# UNITED STATES PATENT AND TRADEMARK OFFICE

APPLICATION NO.	FILING DATE	FIRST NAMED INVENTOR	ATTORNEY DOCKET NO.	CONFIRMATION NO.
10/698,192	10/31/2003	James K. Middlebrook	31254-2	9975
7590 02/28/2005			EXAMINER	
Peter R. Martinez, Esq. LUCE, FORWARD, HAMILTON & SCRIPPS LLP Suite 200 11988 El Camino Real San Diego, CA 92130			TRIEU, THAI BA	
			ART UNIT	PAPER NUMBER
			3748	
			DATE MAILED: 02/28/2005

#### **DETAILED ACTION**

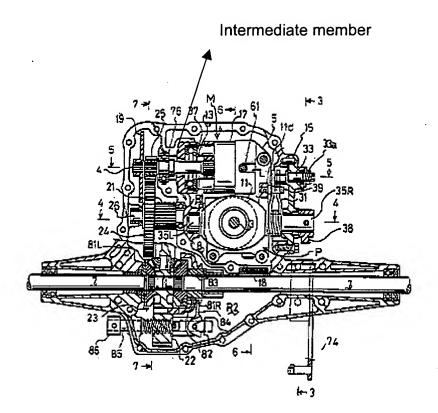
## Regarding claims 8 and 15, Ishii discloses:

a rotatable shaft (4,7) (See Figures 2-3);

at least one bearing assembly (37) disposed around a portion of the rotatable shaft (4, 7) (See Figures 2-3);

a housing element (1,2) surrounding the bearing assembly (76, 37, and bearings support shaft 7); and

an intermediate member (Not Numbered) disposed between the bearing assembly (37) and the housing element (1, 2) (See Figure 2).

wherein the intermediate member (Not Numbered) is substantially cylindrical (See Figure 2).

Tubular spacer portion

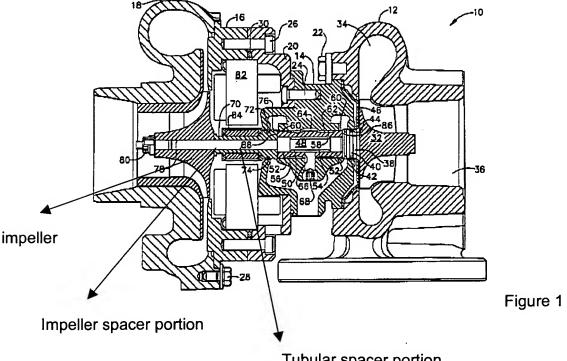
an impeller shaft (48);

an impeller (Not Numbered) directly mounted on to the impeller shaft (48); at least one bearing assembly (60) positioned around a portion of the impeller shaft (48);

a spacer assembly (70) positioned between the impeller (Not Numbered) and the bearing assembly (60) (See Figure 1);

wherein the spacer assembly further comprises an impeller spacer positioned adjacent to a base of the impeller (See Figure 1);

wherein the spacer assembly (18) comprises a tubular spacer positioned around a portion of the impeller shaft (See Figure 1);

wherein the spacer assembly (70) is structured to couple the impeller (Not Numbered) to the bearing assembly (60) (See Figure 1).
